March 14, 2011

TSTF-10-22
PROJ0753

SUBJECT: Revision to Previously Approved Traveler TSTF-490, "Deletion of E Bar Definition and Revision to RCS Specific Activity Tech Spec"

Deletion of E Bar Definition and Revision to RCS Specific Activity Tech Spec

Figure 3.4.16-1 (page 1 of 1)
Reactor Coolant DOSE EQUIVALENT I-131 Specific Activity Limit
Versus Percent of RATED THERMAL POWER With Reactor Coolant
Specific Activity $> 1.0 \mu\text{Ci/gm}$ DOSE EQUIVALENT I-131

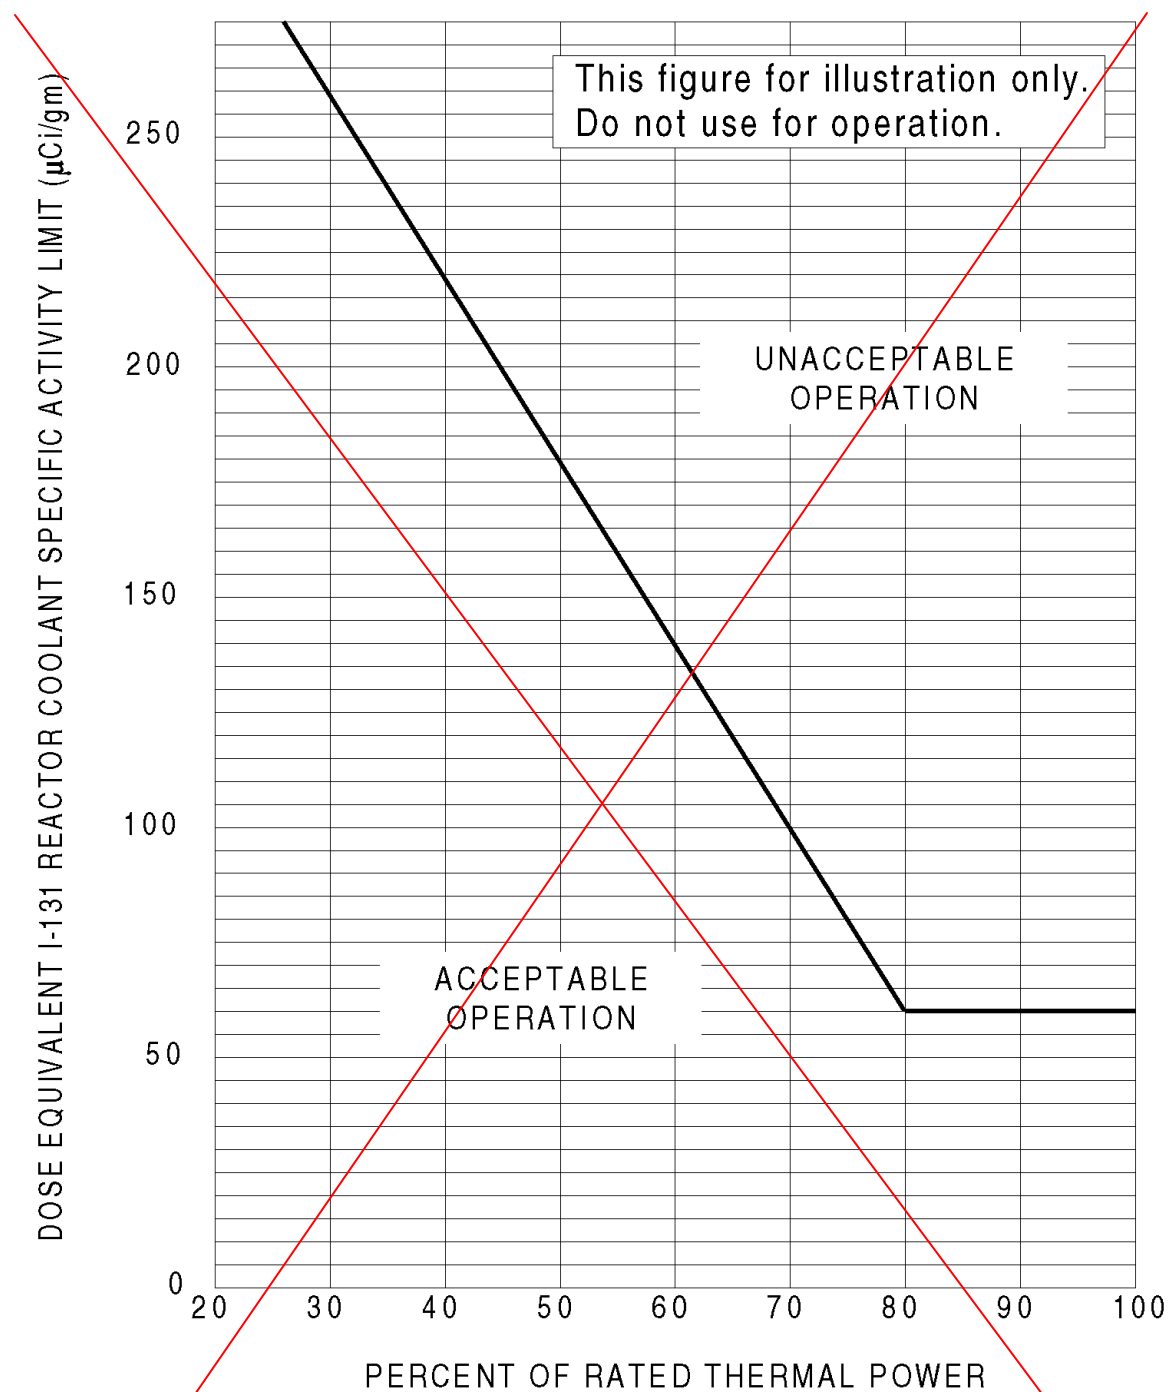
3. Revise LCO 3.4.16 to delete references to gross specific activity, add a limit on Dose Equivalent XE-133, and delete Figure 3.4.16-1, "Reactor Coolant DOSE EQUIVALENT I-131 Specific Activity Limit versus Percent of RATED THERMAL POWER."
4. The Applicability of LCO 3.4.16 is revised to indicate the LCO is applicable in Modes 1, 2, 3, and 4 for those licensees whose accident analyses show the Steam Line Break (SLB) to be a limiting contributor to offsite and control room dose consequences.

Specification 3.4.16, Required Action A.1, is revised to remove the reference to Figure 3.4.16-1 "Reactor Coolant DOSE EQUIVALENT I-131 Specific Activity Limit versus Percent of RATED THERMAL POWER" and to insert a limit of less than or equal to a site-specific Dose Equivalent I-131 spiking limit. The curve contained in Figure 3.4.16-1 was provided by the Atomic Energy Commission (AEC) in a June 12, 1974, letter from the AEC on the subject, "Proposed Standard Technical Specifications for Primary Coolant Activity." Radiological dose consequence analyses for SGTR and SLB accidents do not consider the elevated RCS iodine specific activities permitted by Figure 3.4.16-1 for operation at power levels below 80% Rated Thermal Power (RTP). Instead, the analyses that consider a pre-accident iodine spike assume a Dose Equivalent I-131 concentration 60 times higher than the corresponding long-term equilibrium value, which corresponds to the Figure 3.4.16-1 specific activity limit associated with 100% RTP operation. Therefore, the Specification 3.4.16, Required Action A.1 limit, should be based on the short-term site-specific Dose Equivalent I-131 spiking limit in order to be consistent with the assumptions contained in the radiological consequence analyses.
